## IEEE 1914 NGFI

### Problems with ITU-T G.8271.2 and G.8275.2 Partial Timing Support (PTS) in NGFI

Stéphan Roullot, Nokia

3 January 2019

# Blurred Domains of Responsibilities with PTS

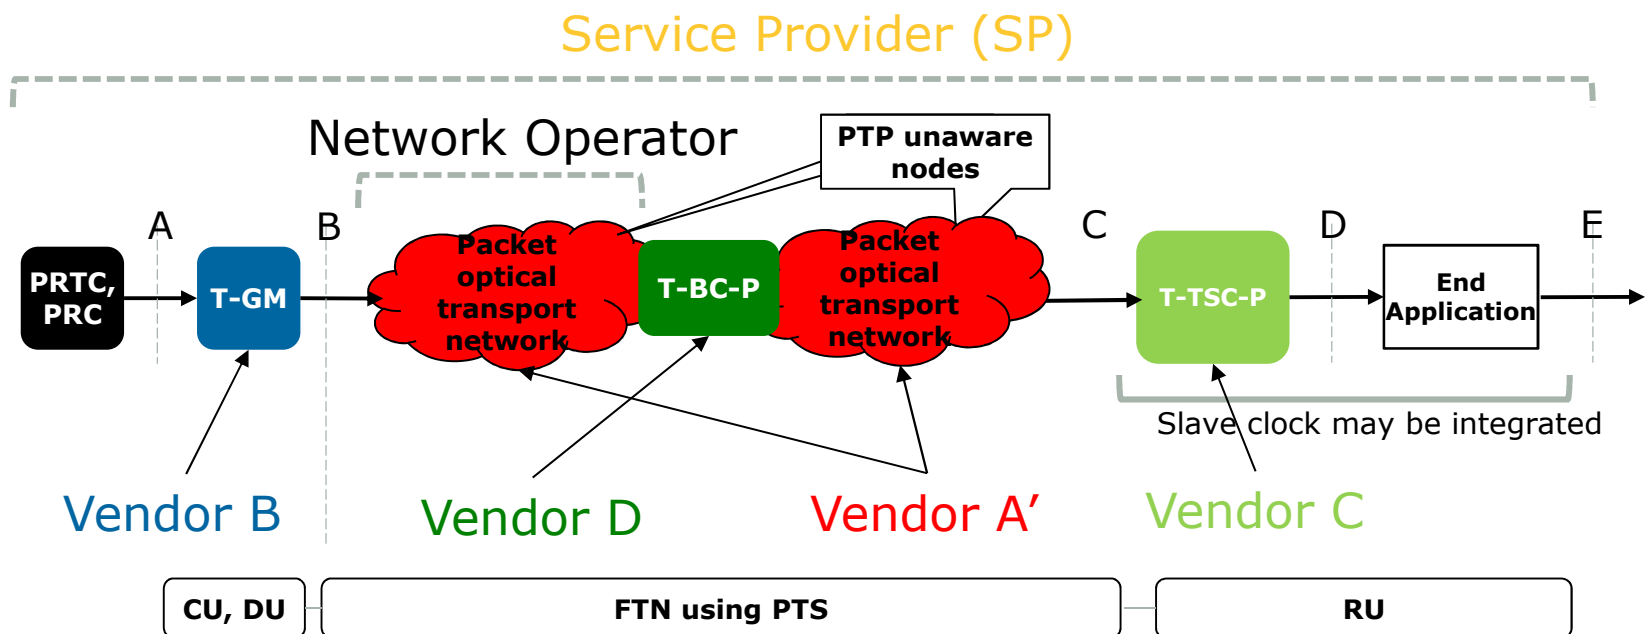
- Which vendor has responsibility – and contractual obligation – to commit to the Service Provider that the timing application requirements will be met?
- Will the SP assume the risks?

# Vacuum of responsibility with PTS

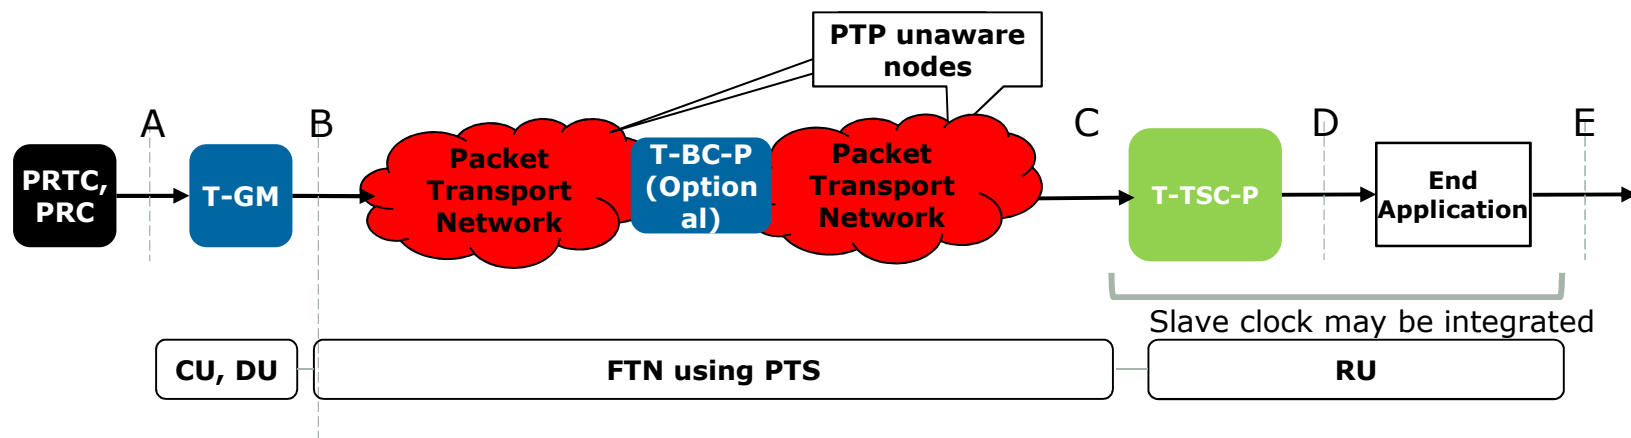
- PTS performance depends on traffic load/pattern and engineering rules.
- With PTS, who defines that the network is “well controlled” and that this is good enough with ALL possible traffic loads/patterns in networks today and in the future?
- Many knobs could potentially have an impact: traffic burst, priority of user/mgt/control plane packets vs. PTP packets under RAN vendor C’s control, PTP-unaware switch design and PDV behavior with different traffic under control of the switch vendor A’ – are not under control of the same party.
- What happens in case of issue? Vendor A’ or D could claim traffic pattern was not envisioned. Debugging and trying to figure out which traffic pattern is endless. Switch vendor A’, T-BC-P Vendor D and RAN vendor C will blame each other.
